Date	18 th February 2026	Issued version	2.0
Author	Ryan Smith, CBEC Eco-engineering UK Ltd		
Technical & Comm. Reviewer	Leonardo Camelo, CBEC Eco-engineering UK Ltd		
To	Gabriel Connor-Streich, Greenshank Environmental		
Project	2150779 – Stodmarsh Stream Enhancement Scheme		
Subject	Design Method Statement – Bliby Wood (Long) and Hinxhill_DD1

1. CLARIFICATIONS/ CORRECTIONS

Table 1.1 Summary of clarifications added to this version of the Method Statement

Figure 4-1 Bliby Wood Spoil Disposal

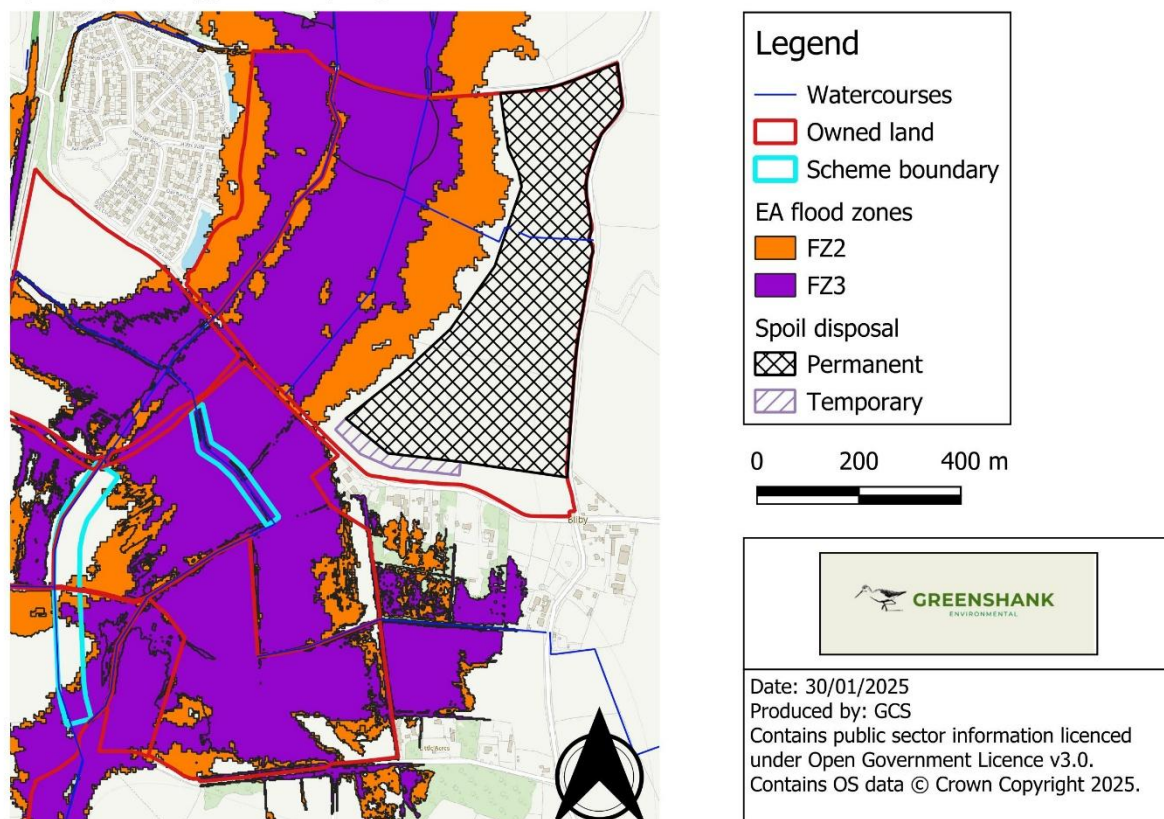
Provide clarity around spoil disposal locations	Section 4.3	A supplementary map has been provided by Greenshank Environmental, showing the locations of spoil disposal outside of flood zones. A statement has been added noting the location and that this outside of flood zone 2 and 3.
Clarify process for temporary spoil storage	Section 4.5	Statement added regarding temporary spoil storage within the floodplain and where most temporary spoil storage will be located.

Creating the new two-stage channels will produce a large amount of spoil. To keep the scheme cost-effective and sustainable, materials should be used onsite to avoid both the financial and carbon costs of transporting material offsite. The main reuse of material will be to fill the existing channels. Any surplus material can also be used to regrade the floodplain benches and channel margins, ensuring smooth transitions between new and existing surfaces. Where surplus material needs to be transported offsite, the landowner has agreed to use exclusively areas of land that are not in Flood Zone 2 or 3. A supplementary map has been provided by Greenshank Environmental (Figure 4.1) that shows the locations of both temporary and permanent spoil disposal. Both temporary and permanent disposal will utilise Flood Zone 1 areas under the landowner's control.

During the excavation of the two-stage channel within the right floodplain, the excavated material will be stored in a 'live' stockpile within the floodplain. Live stockpiles will be removed on the day of deposition to a temporary spoil disposal location, as shown in the spoil disposal supplementary map. The contractor is also likely to move most spoil directly to the temporary disposal location, minimising the size of any live stockpiles within the floodplain. It is recommended that silt wattles be staked to the ground surrounding any stockpiles to mitigate potential sediment runoff during heavy rainfall.
